ZO3 SYSTEM BLOCK DIAGRAM

PROJECT : ZO3
Quanta Computer Inc.

Size Document Number Rev 1A
ATHLON64 HT I/F

SC471A Set

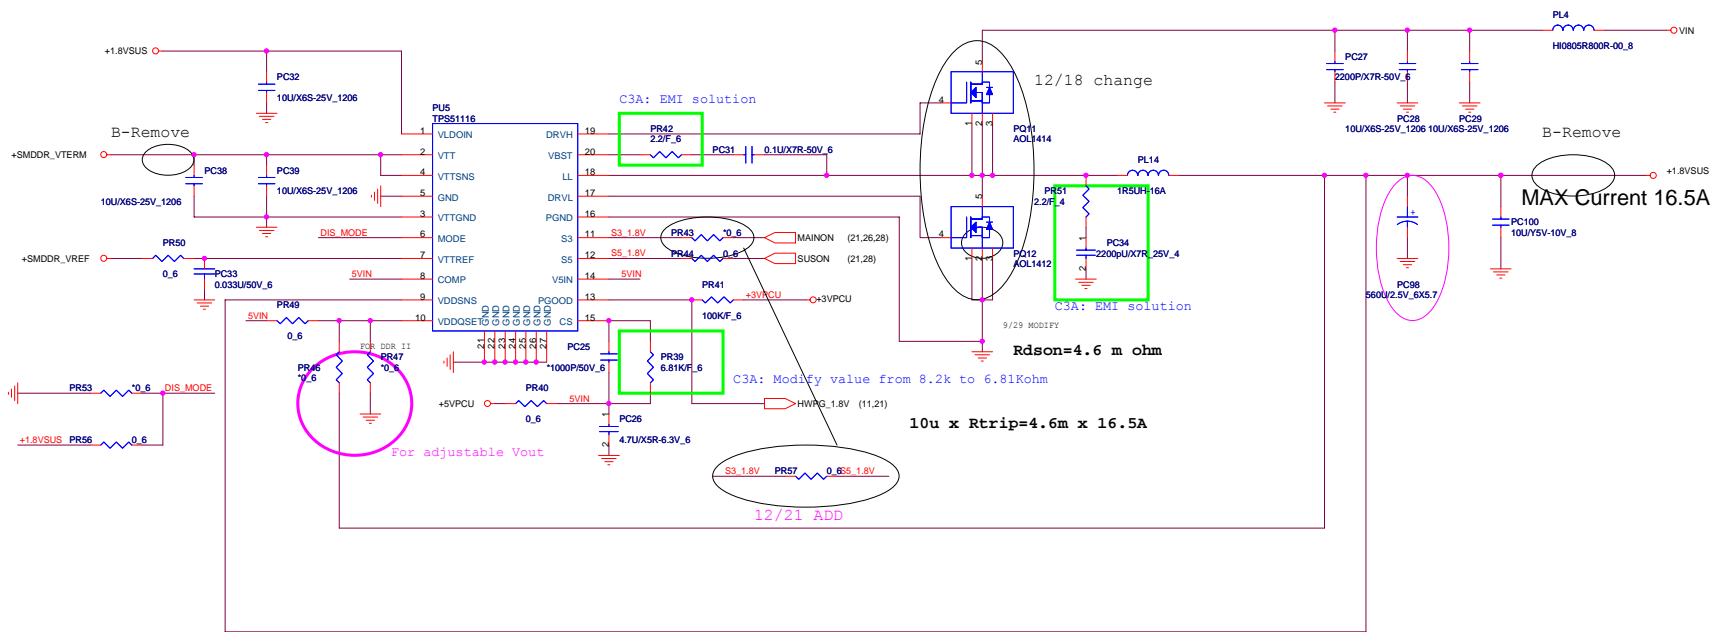
- check: (1) PGD signal: pull high resistor?
 (2) EN pin : connect a resistor to GND.
 (3) suggestion : adding one more IRF7832 as Lowside Mosfet.
